# Access Compliance Report

## Public Rights-of-Way

### (Curb Ramps)

Intersection ID: 2458	Main Street: HIGHLAND_CREEK_PY	Cross Street: MCCHESENEY_DR	Location:	E
ADA ID: A1A10ECB7ECF	Ramp Type: Perp	Initial Pass/Fail: Fail	Overall Compliance: No	Severity Score: 22.5
Codes/Mitigation Info/Possible Solution		Field Measurements/Component Compliance

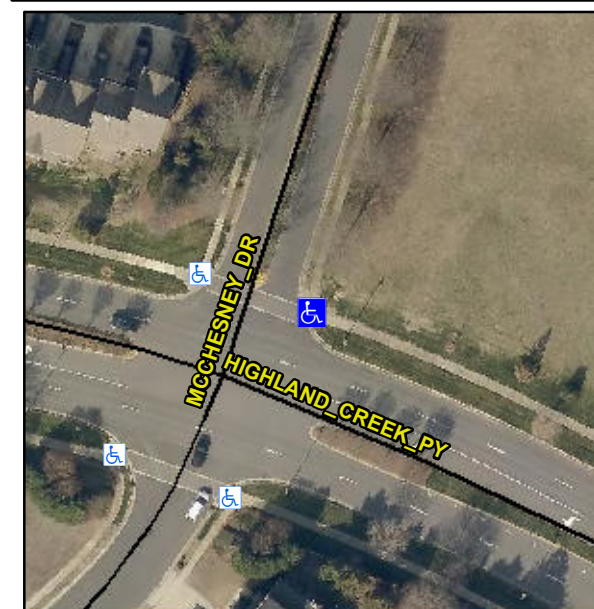
**R304.5.1, R304.2.2, R304.5.3**

Compliance	Description	Data	Compliance	Description	Data
N/A	Ramp Length (in)	45.0	No	Ramp Slope (%)	10.7
No	Ramp Width (in)	40.0	No	Ramp XSlope (%)	3.2
N/A	Flare Type LT	N/A	N/A	Flare Type RT	N/A
N/A	Flare Slope LT (%)	N/A	N/A	Flare Slope RT (%)	N/A
N/A	Flare Traversable LT?	N/A	N/A	Flare Traversable RT?	N/A
N/A	Landing Length (in)	N/A	N/A	DWS Provided?	N/A
N/A	Landing Width (in)	N/A	N/A	DWS Contrast?	N/A
N/A	Landing Slope (%)	N/A	N/A	DWS Length (in)	N/A
N/A	Landing X Slope (%)	N/A	N/A	DWS Full Width?	N/A
N/A	Landing Curb? (Y/N)	N/A	N/A	DWS Offset (in)	N/A
N/A	Shared Landing?	N/A			
N/A	Gutter Ponding?	N/A	N/A	Gutter Slope (%)	N/A
N/A	Gutter Lip Ht (in)	N/A	N/A	Gutter X Slope (%)	N/A
N/A	Painted X Walk1?	Yes	N/A	Painted X Walk2?	N/A
	X Walk 1 Direction	To NW		X Walk 2 Direction	N/A
N/A	X Walk 1 Width (in)	96.0	N/A	X Walk 2 Width (in)	N/A
	X Walk 1 Slope (%)	0.4		X Walk 2 Slope (%)	N/A
	X Walk 1 X Slope (%)	3.2		X Walk 2 X Slope (%)	N/A

**Remove & Replace Entire Ramp.**
